Xavier Rixhon's PhD thesis - Answers to jury members

Exploration of uncertainty-aware energy transition pathways -
Reinforcement learning and principal component analysis-based
methods

I would like to thank the jury members for the comments, which significantly helped improving the manuscript and substantiating the novelty of my work. Based on the notes taken during the private defense, I hereby transcribed, as accurately as possible, the jury's comments.

Figure 1: Storage installed capacities for the REF case

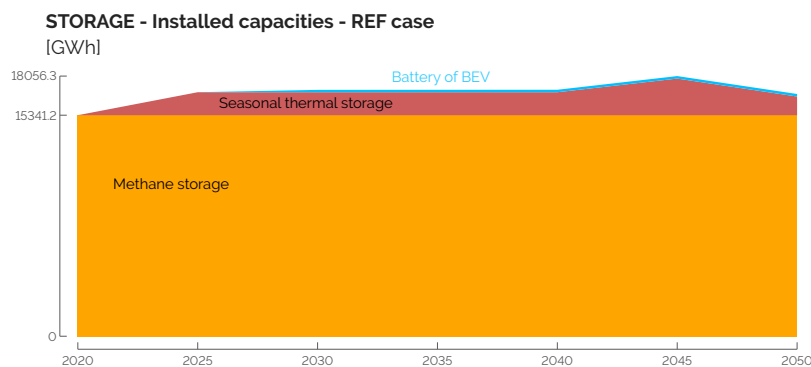
Stefan - Some big topics are missing like storage. Why is storage not more discussed?

As discussed during the private defense, storage is not more discussed in the manuscript for two reasons. First, the storage technologies, for the case of Belgium assuming a copper-plate approach, consist in two main technologies: methane storage mostly (about 15 TWh) and, to a smaller extent, seasonal thermal storage (about 3 TWh), with limited variations through the transition (see Figure 1). Analyses under uncertainties have not shown major variations neither. Second, storage assets are intrinsically linked to the conversion technologies and, consequently, can be seen as by-products of the optimisation results. For these two reasons, I have rather focused my analyses on the use of resources and the installation and operation of conversion technologies. Given the discussion during the private defense and these further explanations, I have not brought modification to the manuscript in this regard.

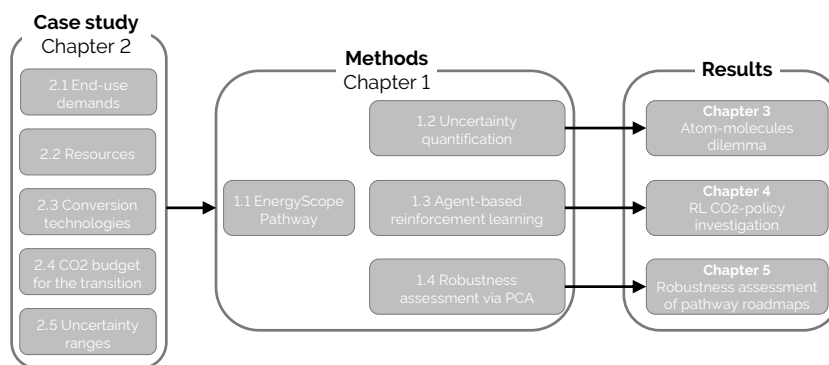
STRUCTURE

Finally, I have added a schematic at the end of the Introduction of the thesis to clarify the structure and highlight that Chapter 4 and 5 can be read after the methodological sections 1.3 and 1.4, respectively (see Figure 2).

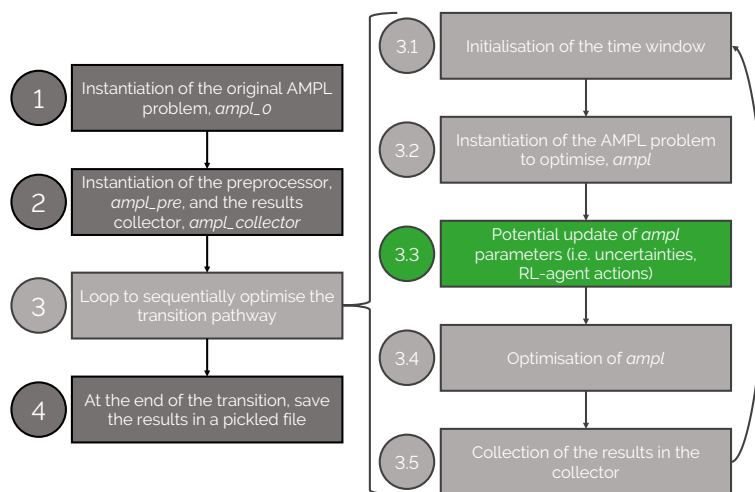
Christophe - Formal description of the problem is missing even in described in the text to make the link between the ideas and the implementation. Add some flow

This point is addressed with the structure chart presented in the previous comment as well as the improvement of Figure 1.4 presenting the implementation of the myopic approach as well as the way uncertainties and RL change the values of some parameters (see Figure 3 of the present document).

and extended the caption of Figure 1.4. However, besides highlighting the key step 3.3 where there is an update of parameters value, I have decided to keep the figure as is since, on the one hand, the extension of the caption provides now a better understanding and, on the other hand, the code itself is exactly what is schematically represented on the diagram.

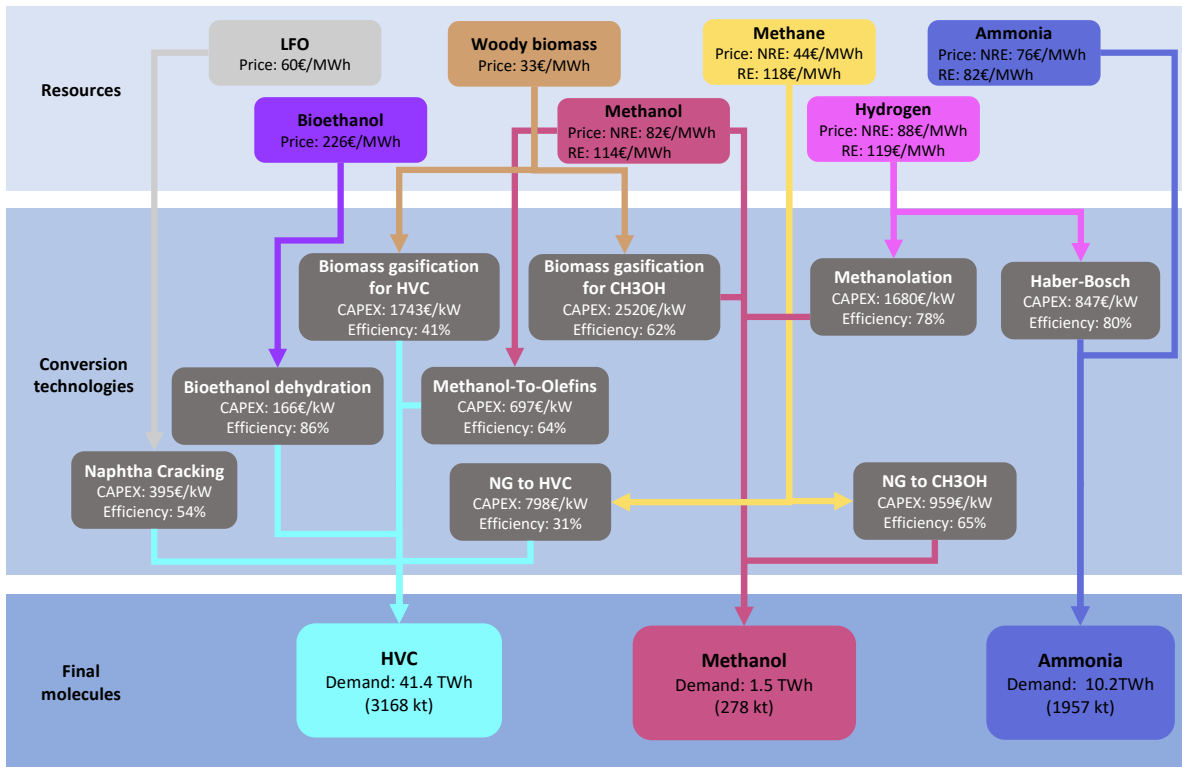
Stefano - Figure 2.5: What is the purpose of the violet line between "biomass gasification" and "methanolation"?

These were actually two different arrows, one pointing from "biomass gasification for CH₃OH" to "Methanol" and the other from "Methanolation" to "Methanol". To avoid this confusion, the figure has been updated and the origin of these arrows are now on different vertical levels ([see Section 2.3](#)).

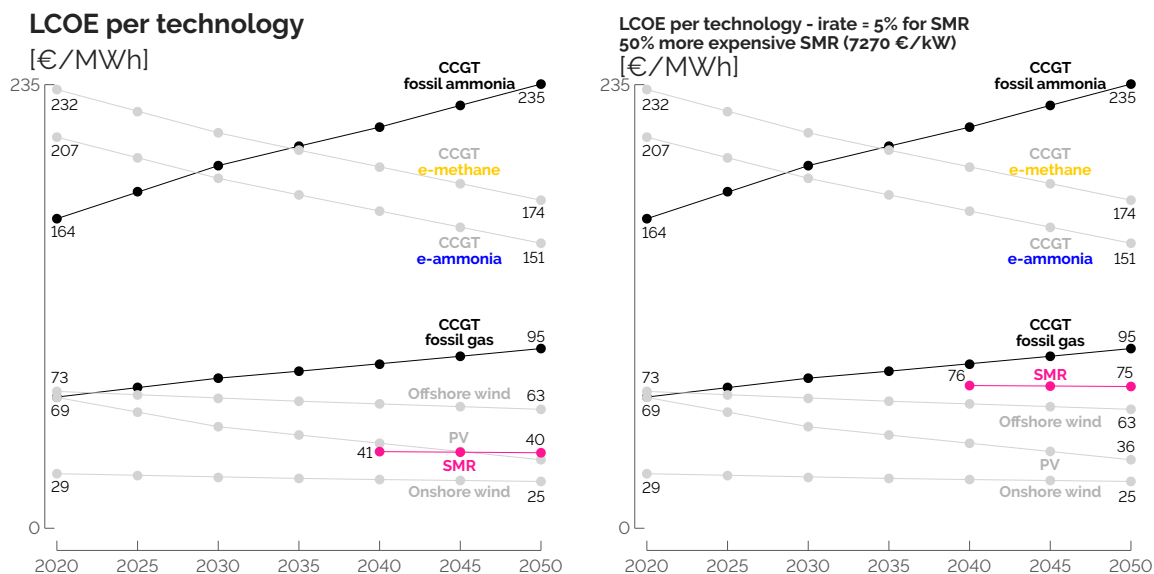
Stefan - SMR must be revisited if a paper is published.

As discussed during the private defense, similarly to EnergyVille [25], we have considered the same CAPEX for SMR as the one considered for conventional nuclear power plants. Where EnergyVille considers a nominal CAPEX of 7500€/kW (like the current large Gen III design of Hinkley Point in the UK), we considered 4850€/kW like the CAPEX of conventional nuclear units in EnergyScope.

On top of the uncertainty applied to the CAPEX of SMR [-40%, 44%] considered in the thesis, I carried out a test on these assumptions by plotting the LCOE of electricity-production units considering different assumptions for SMR (see Figure 4.4). Even considering 50% more expensive SMR subject to a higher discount rate (5% versus 1.5% for the other technologies), we notice that SMR keeps on being

more cost-competitive than other flexible production units, like e-ammonia CCGTs, that are substituted by SMR when the latter can be installed (see Chapter 3). In other words, it means that the optimistic values assumed for SMR in the thesis lead to a cheaper whole-energy system but does not affect its design, i.e., the installed technologies. Consequently, no further modification has been brought to the thesis regarding this comment.

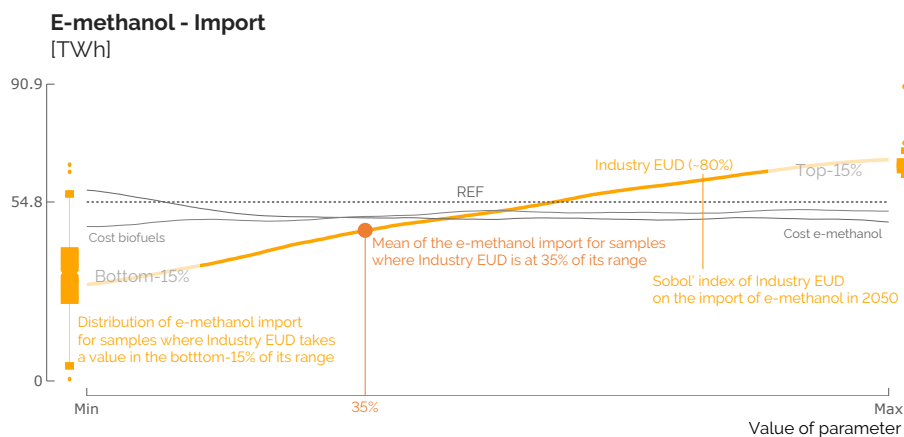
Stefano - p. 74, Figure 3.8: this graphs looks potentially interesting but it is not sufficiently well explained.

The objective of this set of figures is to point out the key parameters that drive the variation of some outputs of interest. Taking the case of Figure 3.8, we focus on the import of e-methanol in 2050. On the x-axis, we represent the value taken by the uncertain parameters in the different samples. As the range is not the same for all the parameters, we have limited this axis from "Min" to "Max". The y-axis represents the feature of interest. The drawn lines represent average trend lines between the output of interest and one specific parameter. For the case of Industry EUD, for samples of the GSA where this uncertain parameter is at 35% of its range, the mean value of methanol imported in 2050 is roughly 50 TWh. The distributions present on the extreme left and right of the graphs correspond to the distributions of the output of interest for the samples of the GSA where the considered parameter takes a value in the bottom (left) or top (right) 15% of its range.

To improve the readability of this figure, I have updated the text zones to specify that these lines and distributions represent results of some specific samples of the GSA. Additionally, I have added a text zone to remind that the value between brackets is the Sobol' index of the considered parameter regarding this specific output of interest, and added this information in the caption of the figure:

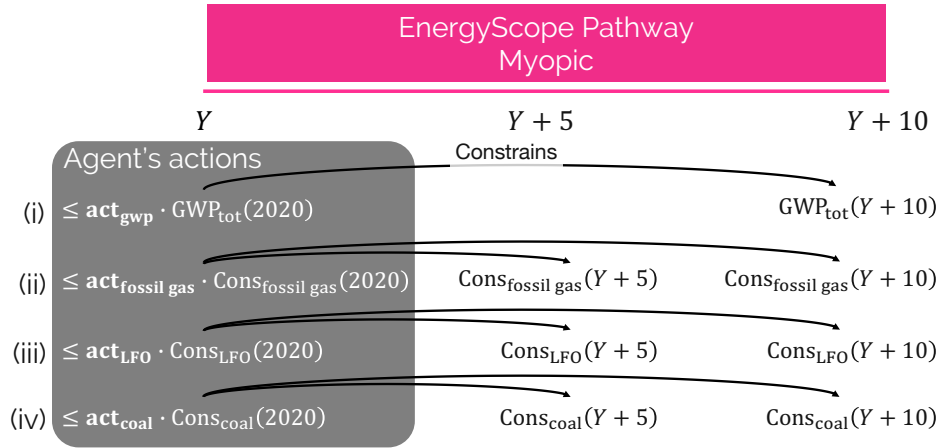
Stefano - Overall, I suggest adding a diagram to Chapter 4, detailing what are the actions available to the decision-maker.

Complementary to the text in the core of the manuscript, I have added a diagram to detail the agent's actions and how they impact the model: taken at the beginning of the time-window to optimise (year Y), the four actions impact (i) the emissions of the system at the end of the time-window (year $Y + 10$) and, (ii-iv) the consumption of fossil gas, LFO and coal at years $Y + 5$ and $Y + 10$.

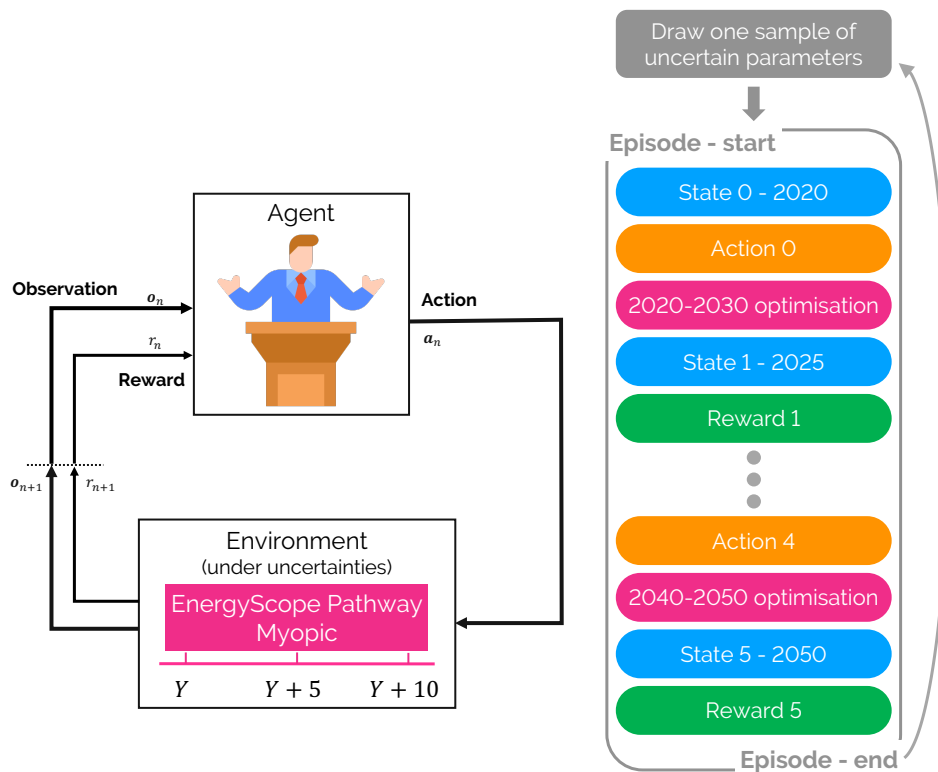
Stefano - Explain more in details the different steps in the RL approach.

Both, agent's actions and exogenous uncertainties, change the value of some parameters of EnergyScope Pathway. However, where the sample of uncertainties is drawn once and for all at the beginning of the episode as explained in Section 1.2.1, the agent's actions are taken at the beginning of each 10-year time window. This is now clarified [at the beginning of Section 1.3.2 and the updated version of Figure 1.7, and its caption](#) (see Figure 8 in the present document):

Before starting an episode, a sample of uncertain parameters is drawn and affects the environment, EnergyScope Pathway, according to the methodology detailed in Section 1.2.1.

Besides the general concepts/fundamentals detailed in Section 1.3.1, the application of the RL approach on the myopic optimisation of the energy transition of a whole-energy system is detailed in Section 1.3.2. Now, Figure 1.7 has been updated to clarify the difference between the uncertainty of parameters and the agent's actions as well as the interactions between the RL code (action, state, reward) and EnergyScope Pathway (optimisation of the concerned 10-year time-window). I have also added a diagram to explain the impact that the agent's actions have on some parameters of the model.
